86100D-13A

Information Only Service Note

86100D DCA-X Wide-Bandwidth Oscilloscope Mainframe

The Argo CPU board, used during repair and upgrade, no longer supports the rear-panel Audio IN, Audio OUT, and Microphone ports

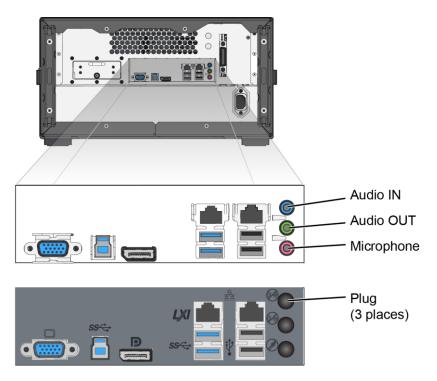
Due to lack of availability of an audio IC, the 86100D Argo CPU board is no longer manufactured with support for the rear-panel Audio IN, Audio OUT, and Microphone ports. These ports are still present and should be plugged and labeled, as shown in the diagram below. This change impacts CPU boards used for repair and CPU upgrade.

86100D DCA mainframes may lose audio port support during CPU upgrade or repair if the CPU board is replaced.

- QTY 3 Plugs (1401-0581) which should be installed by pressing in to cover the audio ports.
- QTY 1 Label for Disabled Audio Flint Gray (54911-94339) for 86100D. This label should be installed as shown above.
- QTY 1 Label for Disabled Audio Titanium Gray (54964-94308) for N1000A. This label is not used for 86100D.

0960-3671: Argo CPU Without Audio IC

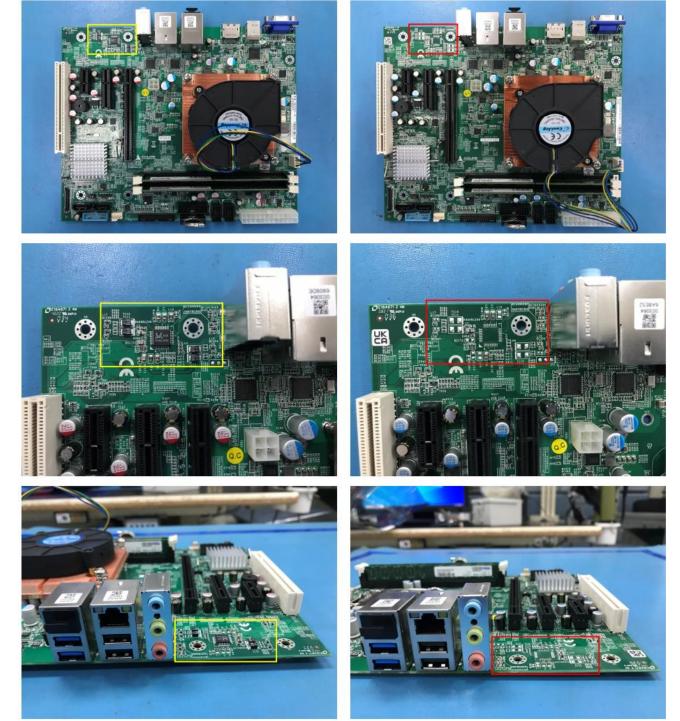
Refer to pictures below to confirm if an Argo CPU has the audio IC installed.
